SERVICE BULLETIN – 01/JULY 2003

SP SERIES

OPTICAL EYES PROTECTION

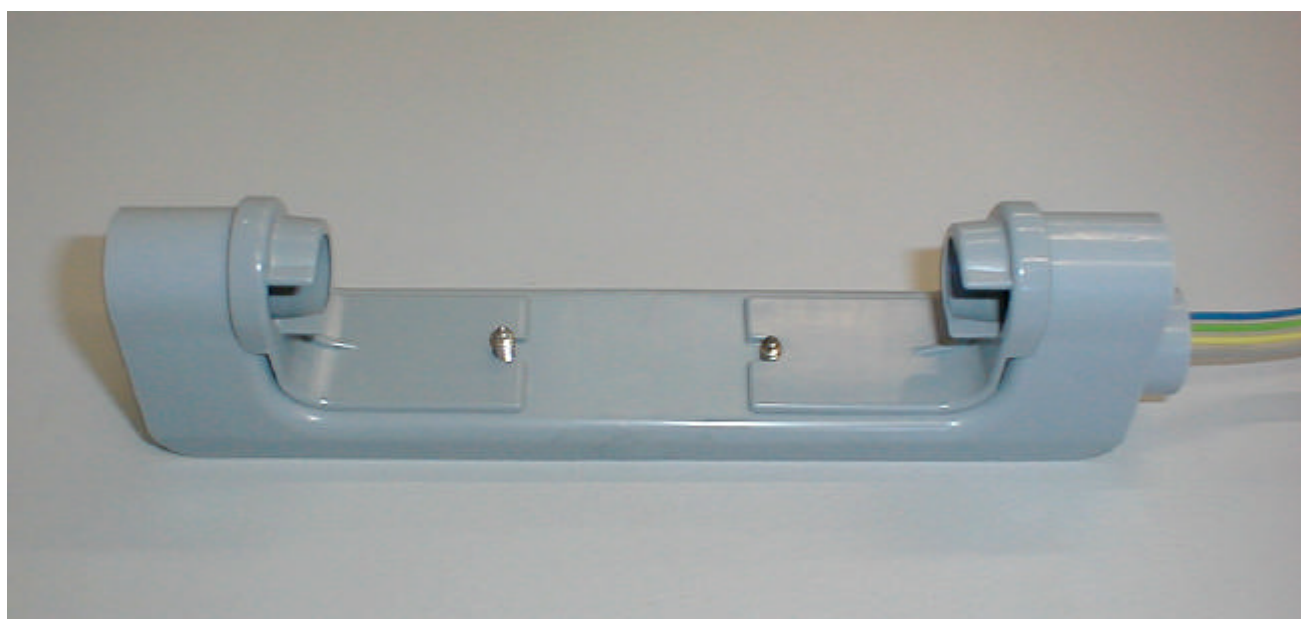
The Flaker machines are now equipped with plastic protection on the Optical Ice Level Control in order to reduce the possibility that external light can affect their operation (see photo).

In case of trouble with the Optical Ice Level Control on machines in the field, we suggest you to install the Plastic Protections, available under the following part numbers:

- Plastic protection left p/n **660720 00**
- Plastic protection right p/n **660720 01**

Pay attention, when the Plastic Protections are fitted on the Ice Level Control of old units, to check for the correct alignment of the EYES through the holes of the ice chute.
